From: "Dan Martin" <martinheitman@comcast.net>
To: <p66-railspur-comments@co.slo.ca.us>
Date: 11/21/2014 08:38 AM
Subject: Opposition to the P66 Rail Terminal Project

To the Attention of Mr. Murry Wilson
SLO County Planning Department

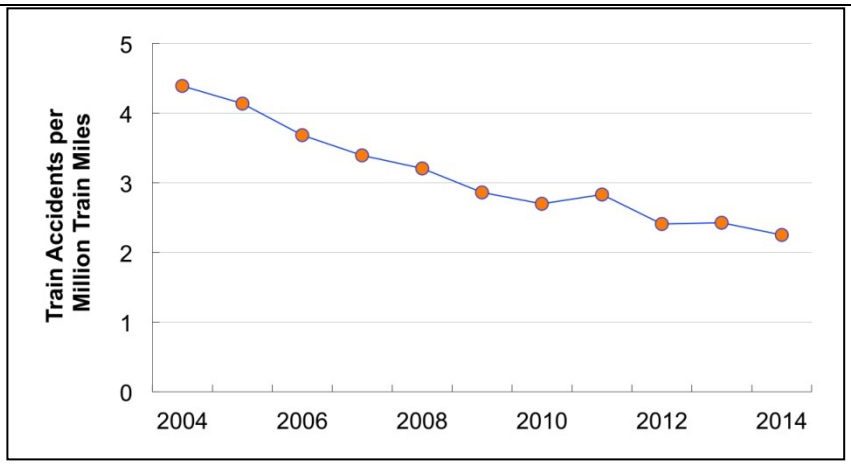
Specifically, our emergency responders are not prepared to deal with potential accidents with these heavy, dangerous trains, and the current safety standards won't protect our people and property along the blast zones. My understanding is that the draft EIR doesn't fully inform our first responders because it inadequately assesses the risks of an oil train disaster in our city; the draft only evaluates rail-accident rates between 2003 and 2012 and the spill rates between 2005 and 2009, while omitting important data about accident frequency and magnitude in more recent years.

This is troubling because we know that more crude spilled from trains in 2013 than during the past four decades combined. The EIR must look at recent data, which reflects the increased quantities of crude being transported in old and unsafe tank cars. MAA-02

Search and Rescue Team, and two members annually from Cal Fire/County Fire or fire districts in San Luis Obispo that have automatic aid agreements with Cal Fire/County Fire for a total of six slots per year for the life of the project. 8. PS-3h Prior to issuance of grading permits, the Applicant shall have an agreement to reimburse Cal Fire/County Fire for Fire Chief Officer attendance such as the 40 hour course offered by Security and Emergency Response Training Center; Leadership & Management of Surface Transportation Incidents. Funding shall be for two Fire Chief Officers annually for the life of the project. 9. PS-3i Prior to issuance of grading permits, the Applicant shall have an agreement with Cal Fire/County Fire to conduct annual emergency response scenario/field based training including Emergency Operations Center Training activations with the Applicant, Cal Fire/County Fire, UPRR, and other San Luis Obispo County First response agencies that have mutual aid agreements with Cal Fire/County Fire. These annual emergency response drills shall occur for the life of the project. Even with the implementation of the above mitigation to reduce the potential for a rail accident and increase local emergency response capabilities, the potential risk associated with the proposed project is considered Significant and Unavoidable (Class I). The historical accidental data used in the RDEIR is not limited to trains shipping crude oil in recent years, but the long term historical train accident data for all freight. The use of data from all freight train movements nationwide provides a very robust database for estimating rail accidents and derailments. Average U.S. train derailment rates over the 5-year period 2005 – 2009 have previously been estimated using data from the U.S. Department of Transportation, Federal Railroad Administration (FRA) Rail Equipment Accident (REA) database combined with traffic data from the rail industry (Liu et al, 2014). This dataset was used to develop detailed derailment rates as a function of three factors: FRA Track Class, traffic volume (which appears to be correlated with additional maintenance above basic federal requirements) and Method of Operation (i.e., signaled or non-signaled trackage). All three of these factors have a significant effect on freight train derailment rate. These factors were used to calculate segment-specific derailment rates thereby enabling a fine grained calculation of derailment probability for any particular route. As discussed below, the overall accident rate has declined since this data was recorded and analyzed, thereby resulting in an overestimate of the present-day risk, and future risk. For example the average accident rate for the five-year period 2010-2014 was 27% lower than the average for the five-year period from 2005-2009, and the preliminary estimate of the accident rate for 2014 was 35% lower than the five-year period from 2010-2014.

The reason data from 2005-2009 was used is because that dataset contained additional information that allowed for the estimated effect of FRA Track Class, Traffic Density and Method of Operation (Signaled or Unsignaled) on derailment rate. This additional granularity is needed for more precise segment-specific accident rate used in the analysis. The derailment rates calculated were based on 1,420 Class 1 railroad mainline derailments. Inclusion of a few more crude oil train derailments in recent years would have virtually no effect on the estimated rates. The suggestion that because these recent accidents were not included in our dataset somehow invalidates the results reflects a lack of understanding of the analytical technique and how it was used. The data needed for this analysis are less complete than for overall accident rate but all other things being equal, there is no reason to believe that crude oil trains derail at a rate different than other freight trains. Using what data are available and making certain assumptions, the EIR consultant conducted an analysis in 2014 and observed no significant difference in the derailment rate for crude oil trains then for other freight trains. The railroad accident rate has been steadily trending downward for over a decade. The accident rates in the past few years were the lowest since the FRA started recording the data in the mid-1970s. In the period from 2004 to 2014 the rate declined by 49% (almost half) (see Figure 1 below). Most derailments receive little or no attention from the public or media. Railroads are required by regulation to report all accidents that exceed a certain monetary threshold in damage to track, signals and rolling stock (currently $9,600). Proper estimation of train accident rates involves analysis of all accidents, divided by the total amount of traffic. The reason that some perceive an increase in the railroad petroleum crude oil accident rate is because of the more than 50-fold increase in this traffic since 2009. Estimates are that 233,698 tank cars of crude oil were moved by rail in 2012. This increased to over 435,000 tank cars moved by rail in 2013 (the full year of data is not yet available for 2014). With this increase in crude by rail traffic, the derailment and spill probability data would suggest that multiple crude by rail accidents would happen each year. Figure 1. Railroad Accident Rate 2004 – 2014

Using the accident and spill probability data from the RDEIR the DEIR would have estimated that between 2012 and 2013 there would have been two to five derailments that had spills of 100 gallons or more in the U.S. Based upon the United States Department of Transportation Pipeline and Hazardous Materials Safety Administration (PHMSA) incident data base, there were three crude oil train derailments with spills of 100 gallons or more.

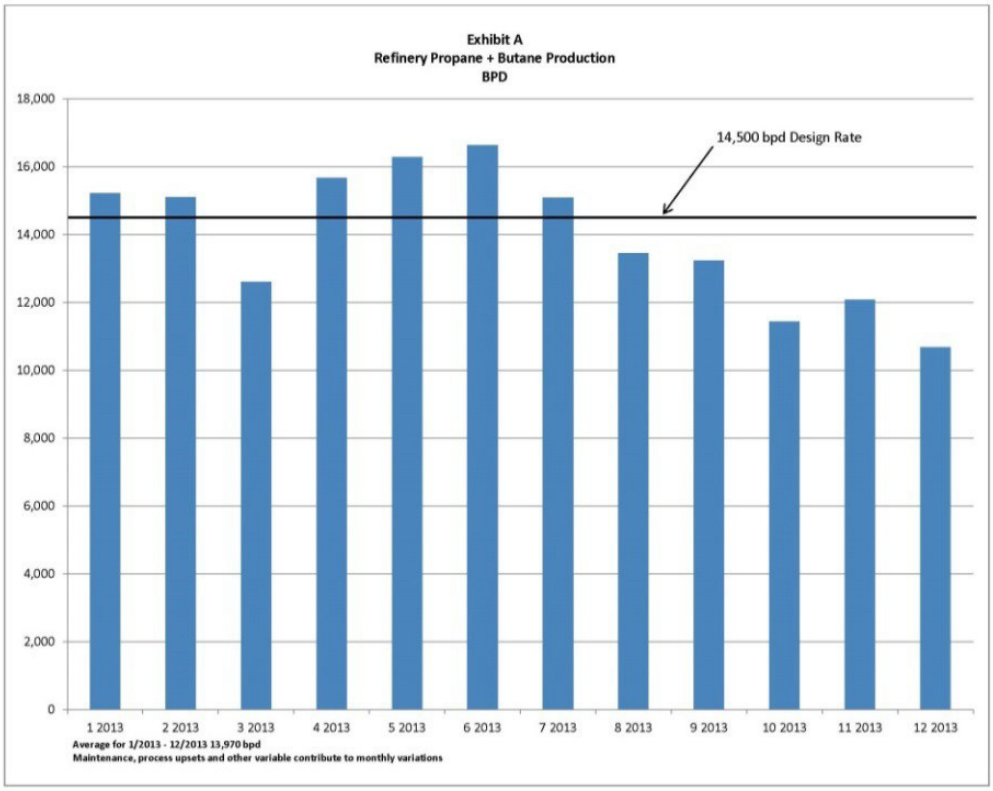
The planning department must examine the cumulative impacts of the Santa Maria and Rodeo proposals as a single project -- not in isolation -- since the proposed terminal in Santa Maria is directly linked by pipeline to the Phillips 66 refinery in Rodeo. Phillips 66 is proposing to modify both facilities to allow it to refine the most toxic crude oil on Earth: Canadian tar sands. MAA-05

SMR is not requesting any changes or modifications to its crude unit or other processing units that would allow it to process any crude types that it can't be process currently. The only proposed change to the Rodeo Refinery is the Propane Recovery Project. The Rodeo Refinery (SFR) produces gases as a byproduct of the refining process, and these gases are used as fuel in various refinery processes (referred to as "refinery fuel gas" or "RFG"). Currently, the propane and part of the butane generated at the SFR is used as RFG. Instead of using the propane and butane as fuel at the SFR, the Propane Recovery Project will allow Phillips 66 to recover, store, and ship propane and additional butane via rail to outside customers. Therefore, the primary project objective is to recover liquid petroleum gases ("LPGs"– i.e., propane and butane) that already exist in the RFG. The Propane Recovery Project will not cause or require an increase in the amount of recoverable LPG present in the RFG; it will simply allow recovery of the LPGs that already are present in the RFG. The Propane Recovery Project is designed to remove up to 14,500 barrels of LPGs per day. Data regarding actual LPG content of the RFG is consistent with the design basis for the project. The figure below shows that, for the twelve month period from January through December 2013, the average LPGs in the Rodeo RFG was 13,970 barrels per day. The equipment design is a limiting factor on the amount of propane and butane that can be captured and stored, regardless of how much propane and butane can be produced by the SFR in the future or what type of crude oil is processed. Phillips 66 specified this design basis in the application to the Bay Area Air Quality Management District for an authority to construct the Propane Recovery Project, and it has been translated into an enforceable condition included in the draft permit prepared by the air district. Therefore, the amount of propane and butane to be extracted once the Propane Recovery Project is operational will be constrained by the physical design of the equipment and the permit limits. Most of the LPG produced at the SFR does not arrive as propane and butane in crude oil or in the semi-refined products received from the Santa Maria Refinery (SMR). Rather, the vast majority of LPG produced at the SFR is created through the refining process itself. As explained above, the design capacity of the Rodeo Propane Recovery Project was sized to recover LPGs that are currently being produced and burned as part of the refinery fuel gas at the SFR. No changes in the crude delivery system, type of crude or operations at the SMR are needed in order to fully utilize the propane recovery unit in Rodeo.

The commenter's have overlooked the fact that the refining process at the SFR itself accounts for 90% of the propane and butane currently produced and proposed to be recovered by the Rodeo Propane Recovery Project. As described at pages 3-8 to 3-9 of the Recirculated Draft Environmental Impact Report for the Propane Recovery Project, the refining process incorporates four primary functions: separation, conversion, purification and blending. Crude oil and other incoming feed streams contain mixtures of various hydrocarbon compounds that can be separated using distillation and fractionation in the first step of the refining process. At the SFR, a small amount of butane and propane is separated from the crude oil in these first stage processes. However, butane and propane are also created from other hydrocarbon compounds during the conversion phase of the refining process. Overall approximately ten percent of the LPG (combined butane and propane) arrives as identifiable fractions of the crude oil, and the balance of approximately ninety percent is created in the refining processes (cracking units).

Since LPG in the crude oil accounts for only a very small fraction (approximately ten percent) of the total LPG produced at the SFR, a change in crude oil LPG content in Santa Maria or in Rodeo would have very little effect on the volume of LPG available for recovery at Rodeo.
